Ref: 6129

## LEESTON PLAN CHANGE - RFI RESPONSE

Thank you for your letter dated 19 September requesting further information regarding Plan Change PC190062: Private Plan Change Leeston. Baseline Group has prepared the following response.

Leeston Plan Change

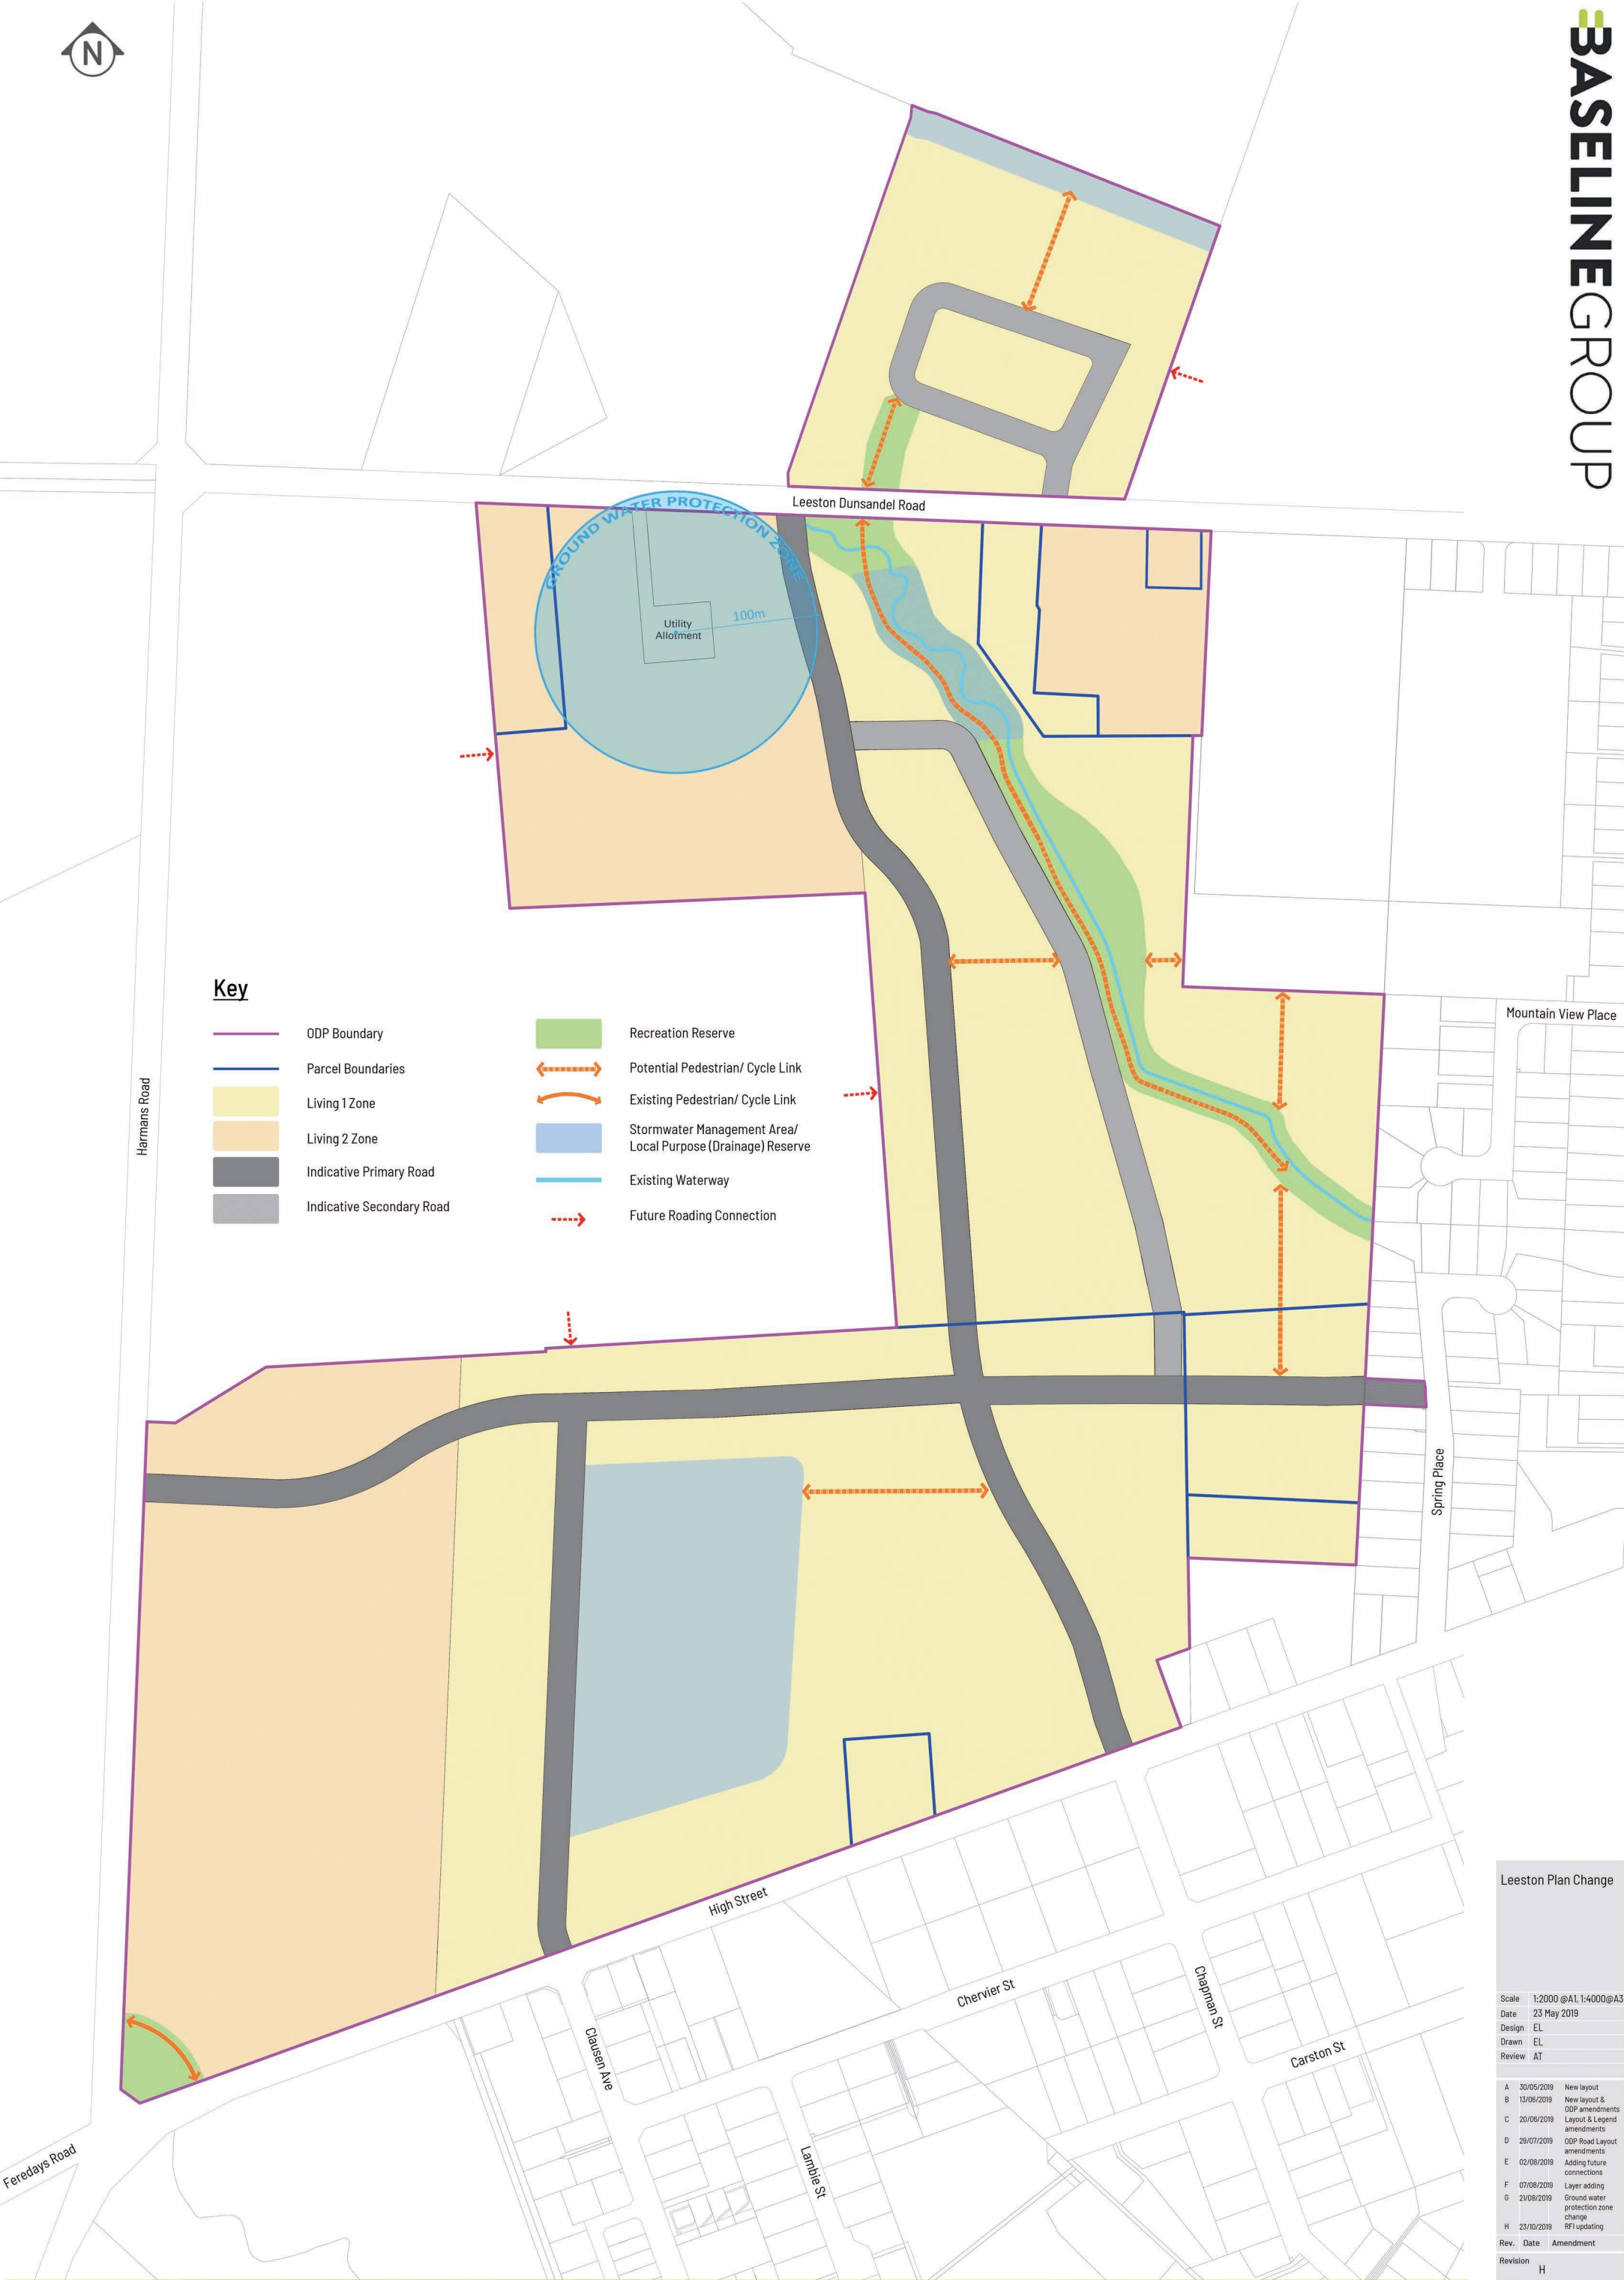
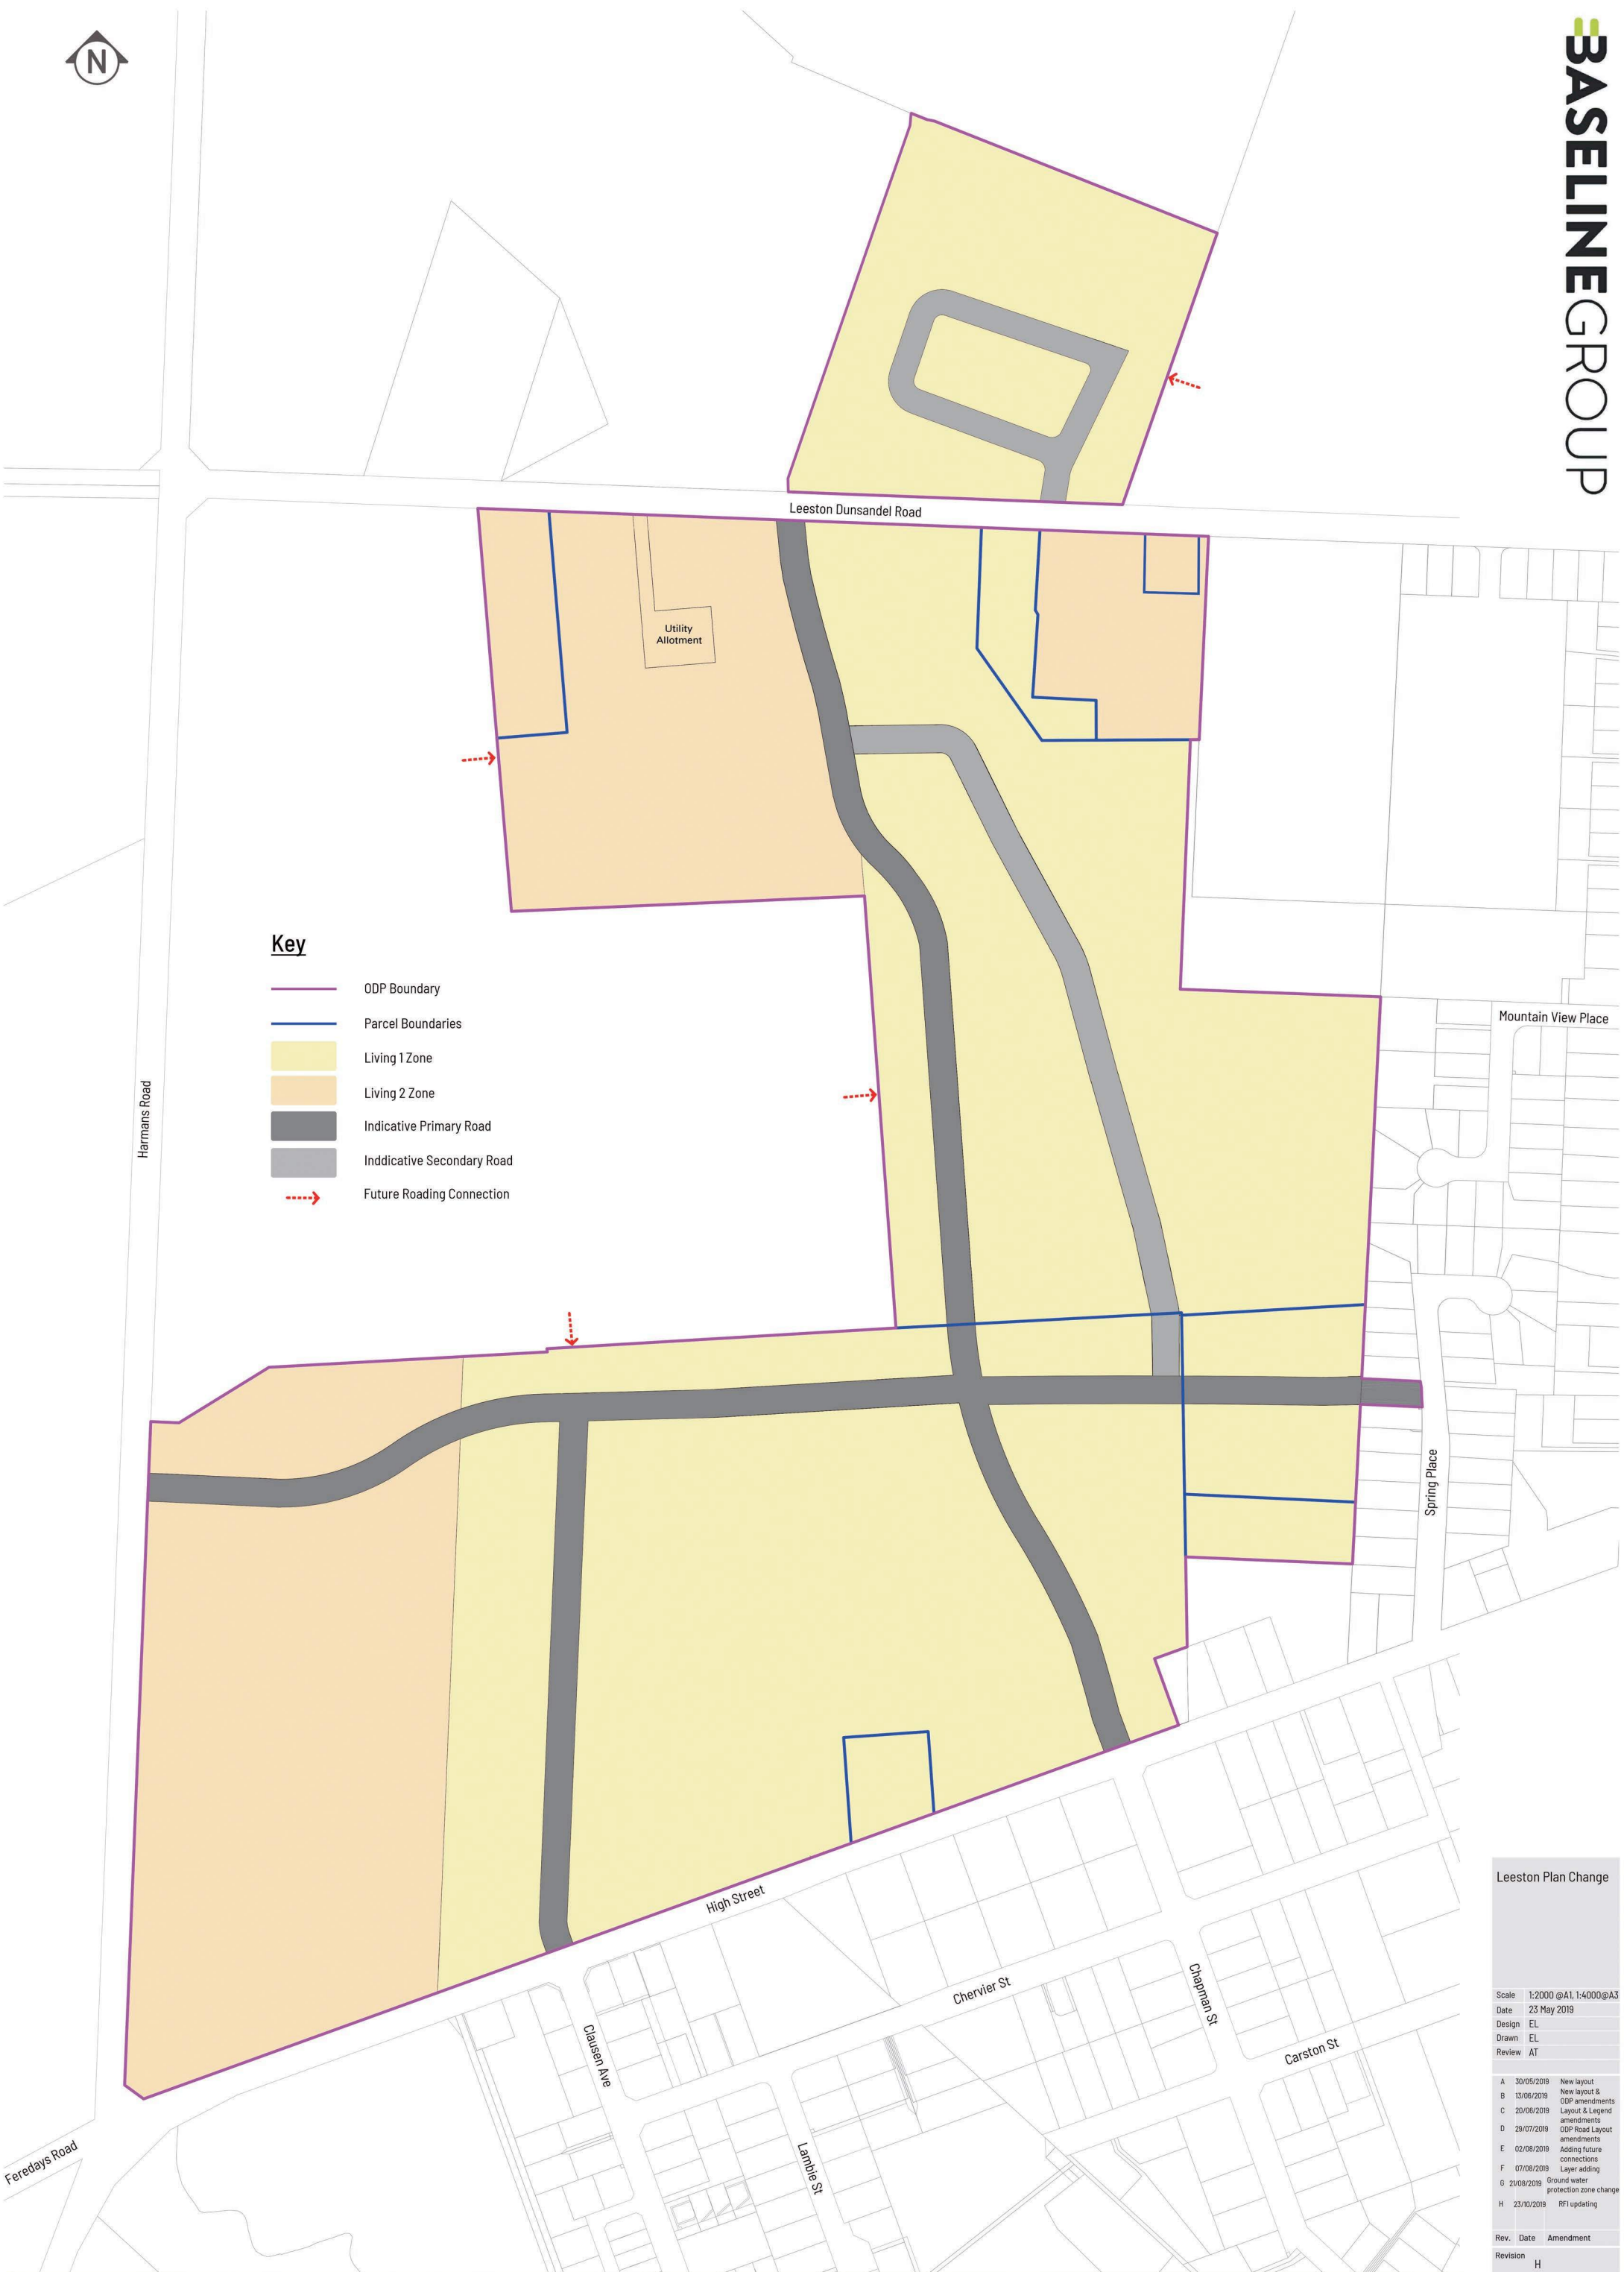
12. As highlighted in yellow below, the ODP should show a specific pedestrian/cycle link along the main reserve/water course alignment. The ODP should also show a pedestrian/cycle link from the northern part of the to the future stormwater reserve area along the northern boundary of the site.

16. *To address CPTED issues, the proposed reserve along the creek should have extensive road frontages, rather than being behind houses, as reflected in the indicative subdivision plan included in the Transportation Assessment.*

*17. There are small inconsistencies between the overall ODP and the transport network in terms of the pedestrian/cycle links. Please resolve these. It is noted that a continuous alignment is preferred.*

*18. A future roading connection is also desirable from the northern Living 2 residential portion of the site to the west and south, connecting into the balance Rural (Outer Plains) Zone, to future proof accessibility within this locality.*

*19. The names of the surrounding roads should also be shown on the ODP.*

These have been added to the ODP and a revised copy of the ODP is attached in Appendix 4.

The ODP (see appendix 4) has been amended so the reserve along the creek has road frontage with the secondary road.

The ODP has been amended to resolve the inconsistencies between the overall ODP and the transport network plan and is attached in Appendix 4.

A future road connection has been provided on the ODP from the northern Living 2 portion to the west. Three roading connections to the block of land west of the plan change site is considered sufficient to future proof any development. It is noted the site to the west is zoned Outer Plains, so any future residential development would require a plan change and an outline development plan.

Road names have been added to the ODP plans in Appendix 4.

The ODP plans have been amended and are attached to this letter in Appendix 4.
